Kitchen Machines in Titanium range

New Motor & Control Module

May 2017

Old Motor and Controller

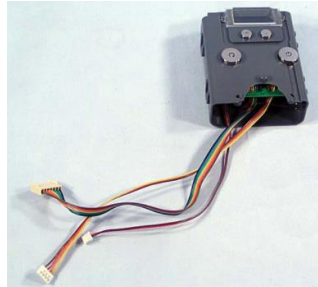
Due to a change of Supplier, the Motor **KW713924** is replaced by the new Motor **KW715912**.
The Control Module **KW710359** is replaced by the new Control Module **KW715913**.

KW713924 must be used with **KW710359**.

KW715912 must be used with **KW715913** and **KW717305**.
